Access Compliance Report Public Rights-of-Way (Curb Ramps)

Intersection ID: 47585	Main Street: EVANTON_LOCH_RD	Cross Street: SEAMILL_RD	Location: NE
ADA ID: 702F6B042047	Ramp Type: PerpDiag	Initial Pass/Fail: Fail	Overall Compliance: No Severity Score: 12.5

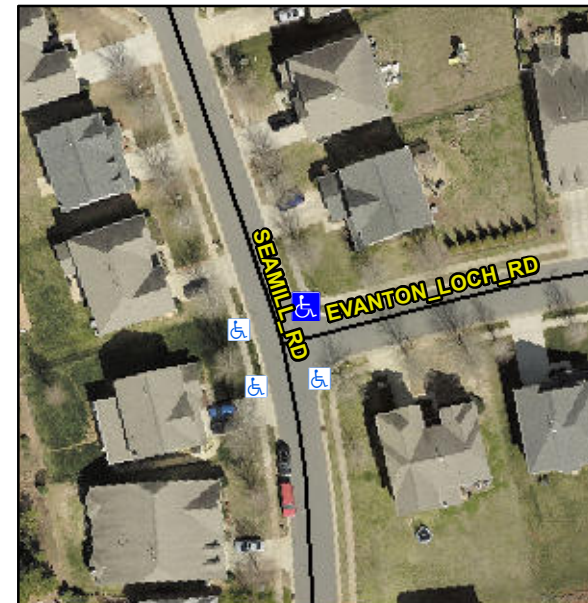
R304.2.2

Compliance	Description	Data	Compliance	Description	Data
N/A	Ramp Length (in)	48.0	No	Ramp Slope (%)	8.7
Yes	Ramp Width (in)	48.0	Yes	Ramp XSlope (%)	1.1
N/A	Flare Type LT	N/A	N/A	Flare Type RT	N/A
N/A	Flare Slope LT (%)	N/A	N/A	Flare Slope RT (%)	N/A
N/A	Flare Traversable LT?	N/A	N/A	Flare Traversable RT?	N/A
N/A	Landing Length (in)	N/A	N/A	DWS Provided?	N/A
N/A	Landing Width (in)	N/A	N/A	DWS Contrast?	N/A
N/A	Landing Slope (%)	N/A	N/A	DWS Length (in)	N/A
N/A	Landing X Slope (%)	N/A	N/A	DWS Full Width?	N/A
N/A	Landing Curb? (Y/N)	N/A	N/A	DWS Offset (in)	N/A
N/A	Shared Landing?	N/A			
N/A	Gutter Ponding?	N/A	N/A	Gutter Slope (%)	N/A
N/A	Gutter Lip Ht (in)	N/A	N/A	Gutter X Slope (%)	N/A
N/A	Painted X Walk1?	No	N/A	Painted X Walk2?	No
	X Walk 1 Direction	To W		X Walk 2 Direction	To S
N/A	X Walk 1 Width (in)	N/A	N/A	X Walk 2 Width (in)	N/A
	X Walk 1 Slope (%)	1.5		X Walk 2 Slope (%)	3.8
	X Walk 1 X Slope (%)	1.6		X Walk 2 X Slope (%)	1.3

Remove & Replace Curb Ramp With Two New Directional Ramps or Equivalent.
